ADDENDUM NUMBER 8

- 1.01 DATE: APRIL 13, 2021
- 1.02 PROJECT: WELCOME CENTER
- 1.03 PROJECT NUMBER: DCM NO. 2020604
- 1.04 OWNER: ALABAMA A&M UNIVERSITY
- 1.05 ARCHITECT: NOLA | VAN PEURSEM ARCHITECTS, PC

4 WALL SECTION - DRINKING FOUNTAIN
3/4" = 1'-0"

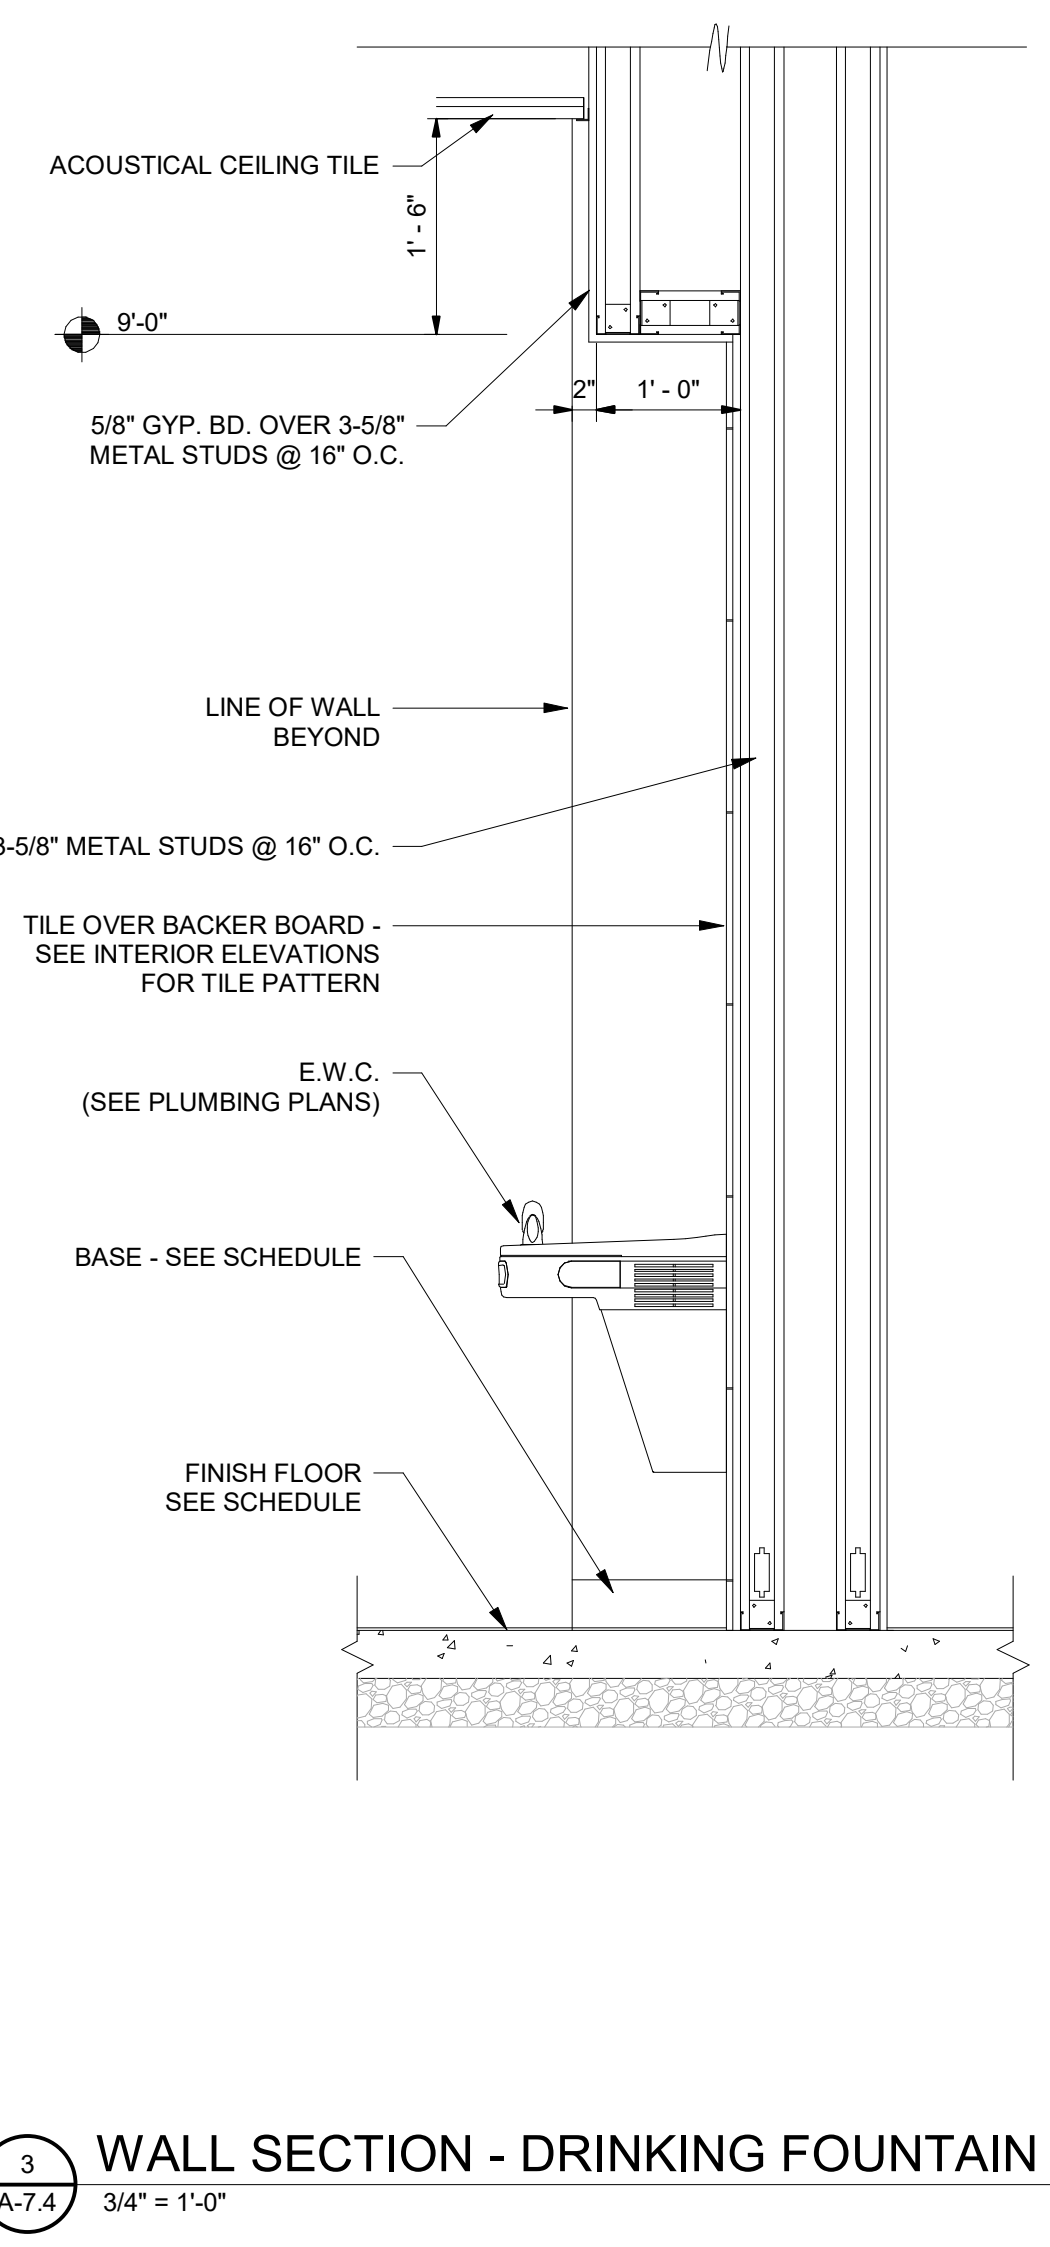
4.04 SHEET A-7.4 – WALL SECTIONS:

A. Replace this sheet in its entirety. Revisions include: two added wall sections.
